TO: Mark J. Purple – Town of Southborough
FROM: Timothy P. Thies, PE – Pare Corporation
CC: William J. Cundiff, PE – Southborough DPW
RE: Pare Memo RE: MassDEP January 7, 2026 Letter
Southborough Landfill Monitoring Project
Pare Project No. 18128.06

***01/07/2026 Southborough Parkerville Road LF
Exceedance Response Letter***

Re: CERO – SWM – Parkerville Road Landfill, Southborough, Massachusetts, Reported Exceedance(s) of 310 CMR 19.132(h) Parameter(s)

11/13/1996 CSA GW Contour Plan

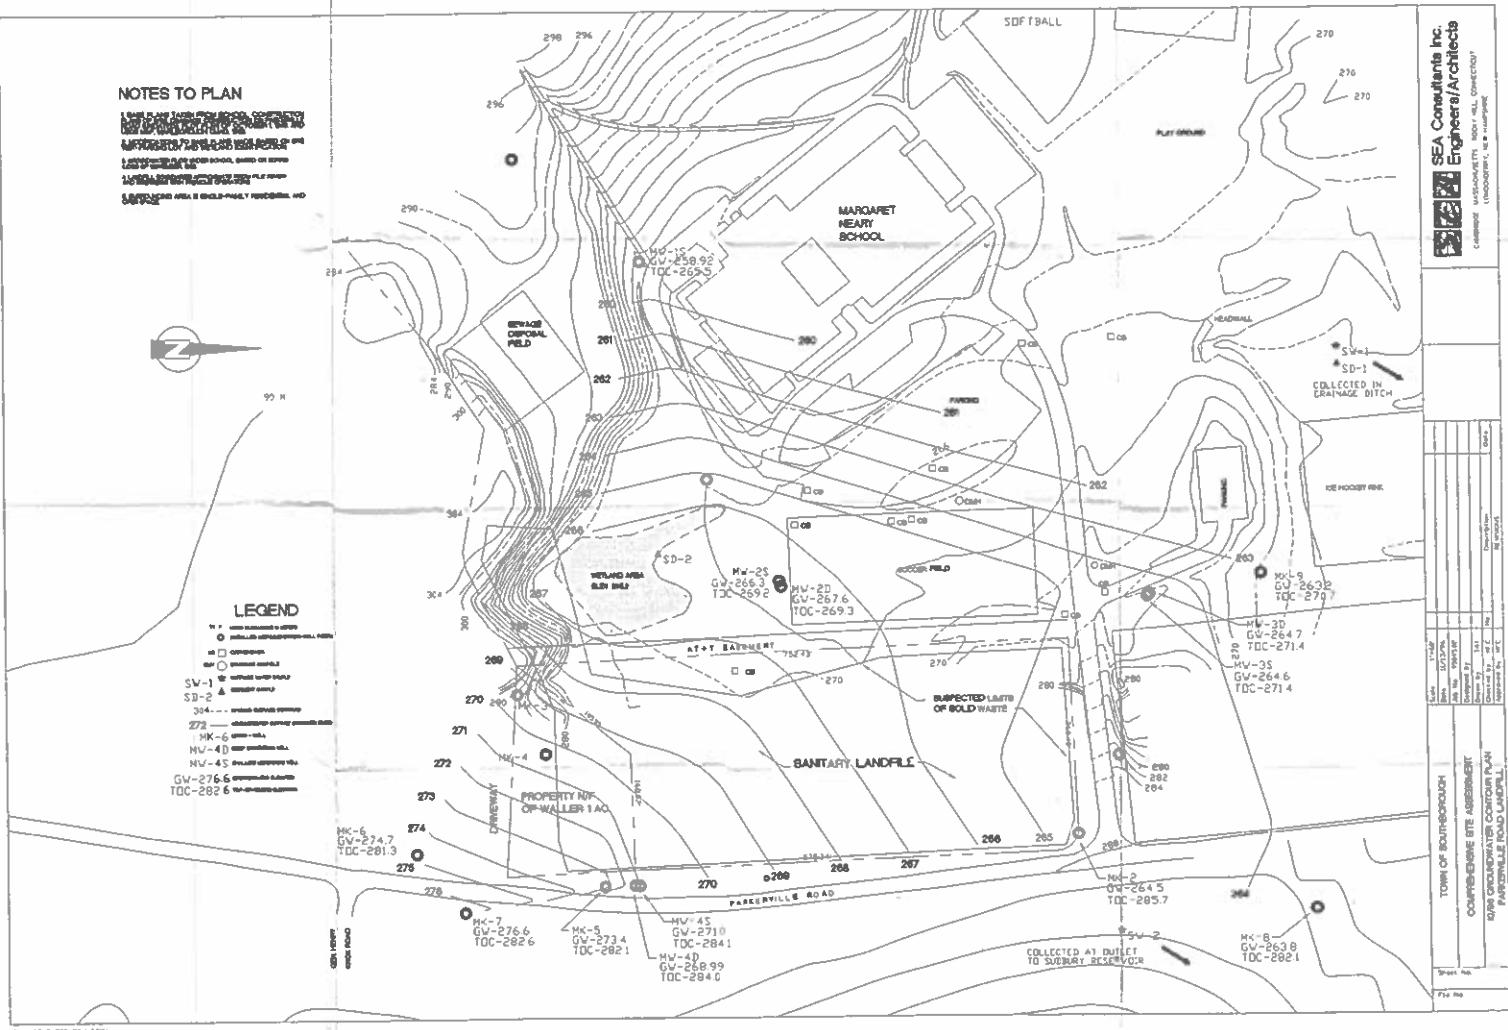
(these wells have since been destroyed or removed). Based on these microwells, groundwater flow direction at and downgradient of the landfill is understood to flow from the southeast to the northwest. It appears groundwater flows toward a small pond and a large wetland complex located north of the Neary School access road. Both features are topographically lower in elevation than the landfill and the surrounding area. The location of the wells and groundwater flow direction, as well as a copy of the original groundwater flow map produced in 1995, are included herein as Attachment Nos. 2 and 3, respectively.

1,4-Dioxane in MW-3S and MW-3D Since 2015

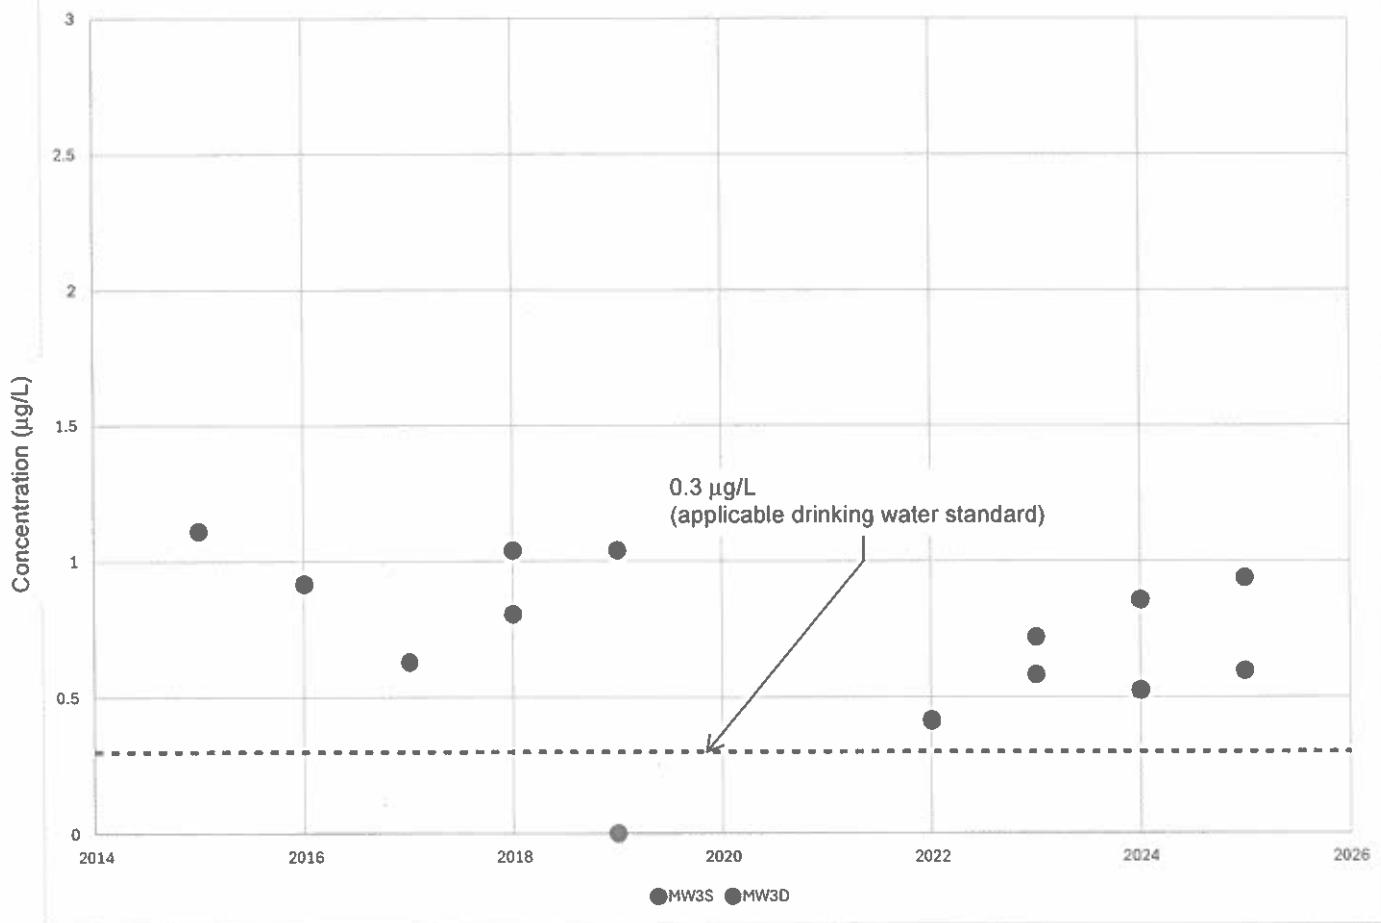
With regard to the concentration of these parameters, while they exceed applicable standards at some locations, the concentrations are generally low. As shown on the attached graphs, 1,4-dioxane has generally been reported in the range of 0.5 and 1.2 mg/L and arsenic has been reported at concentrations similar to its MCL – sometimes just above the MCL and sometimes just below the MCL. The applicable standards referenced herein are intended to be protective of individuals who might have long-term exposure to these contaminants; for example, a person who might be drinking water with these contaminants every day for 30 years could suffer ill effects due to such long-term exposure. If a person were to have incidental or short-term exposure to the groundwater beneath the landfill, which is very unlikely, the potential health effects would be less. As it pertains to 1,4-dioxane, the concentration in groundwater that would be needed to create an indoor air risk is several orders of magnitude higher than what has been reported in groundwater beneath the landfill. The MassDEP groundwater standard for 1,4-dioxane that specifically addresses volatilization and indoor vapor intrusion is 5,000 mg/L, which is 5,000 to 10,000 times higher than what has been reported in groundwater beneath the landfill. So, while it is important to monitor groundwater for these parameters now and in the future, at their current concentrations, they pose a low risk to human health.

1,4-Dioxane – Applicable Standard 0.3 ug/L

- Groundwater Monitoring Well MW-3S at 0.939 ug/L
- Groundwater Monitoring Well MW-3D at 0.598 ug/L
